Access Compliance Report

Public Rights-of-Way

(Pedestrian Signals)

Intersection ID: N/A	Main Street:	Cross Street: N/A	Location: N/A
ADA ID: 6FEF96B08946	Signal Type: One Push Button-Non APS	Overall Compliance: No	Severity Score: BTN 1: N/A BTN 2: N/A No BTN: N/A
Codes/Mitigation Info/Possible Solution		Field Measurements/Component Compliance

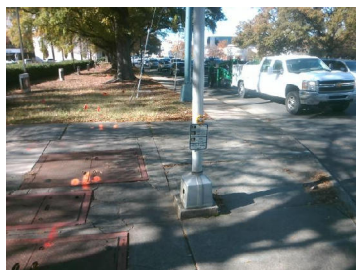
Possible Solutions: Replace Signal Push Button With APS Button on New Post. Remove & Relocate Sign.

PROW/ADA: TMUTCD 4e.08, R404.2
